Docket Item # 9  
BAR CASE #2008-0183

BAR Meeting  
November 5, 2008

**ISSUE:** Alterations

**LOCATION:** 817 King Street

Existing Rear Elevation

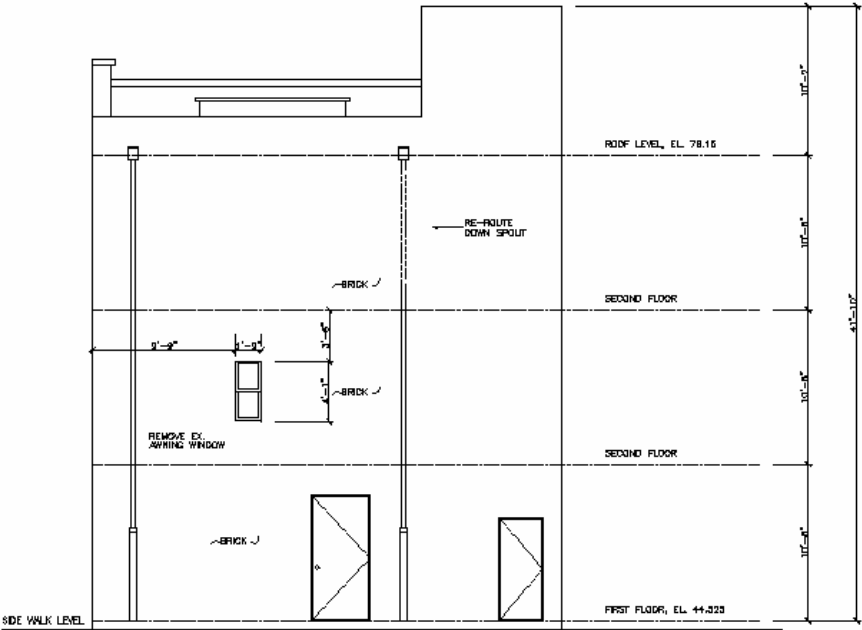
1. Penetrate the existing rear CMU block wall (north elevation) on the subject retail building at 817 King Street to install six (6) new windows. The proposal is requesting to install two, double-hung windows and one, single-light, fixed sash window with a bronze, anodized aluminum frame on the second and third floors of the building's rear elevation.
2. Create an ADA accessible entry by removing an existing 4" high x 3' long threshold at the front entry door and re-positioning the existing glass door 4" lower. Fill in the 4" gap above the door with new glass. Install an ADA wall plate actuator to the left of the entry door.

Proposed Rear Elevation

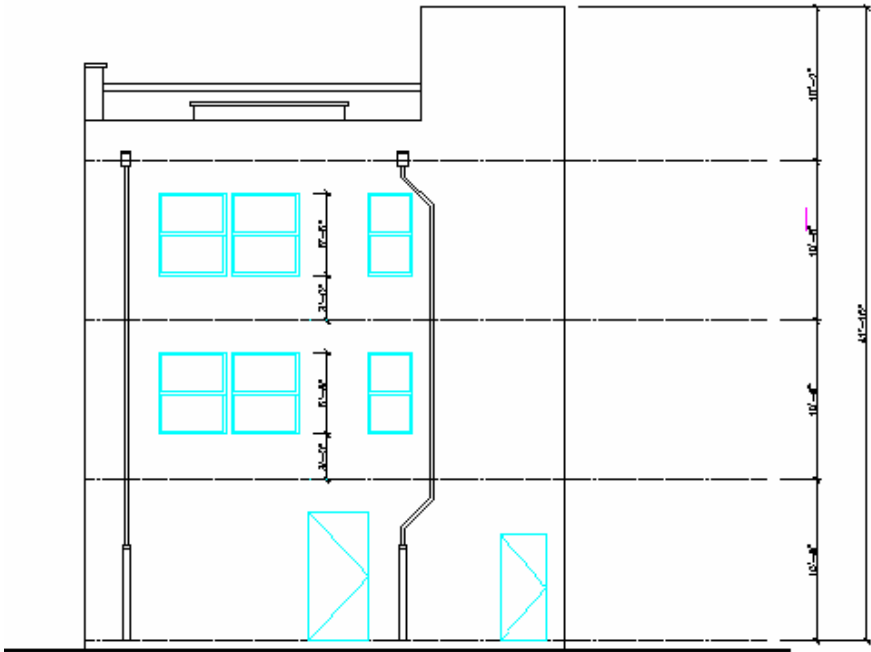
The windows on the front façade of this building are single-plate glass windows trimmed in metal. The proposal is to install metal windows on the rear elevation of this building. The Applicant has selected building materials which complement the architectural style and age of this building, thus the alterations will not detract, rather will blend into the building's existing fabric. Additionally, the minor changes to the building's front façade to provide the store with an ADA accessible entrance will not negatively impact the historic streetscape.

Staff recommends approval of the application for a Certificate of Appropriateness as submitted.
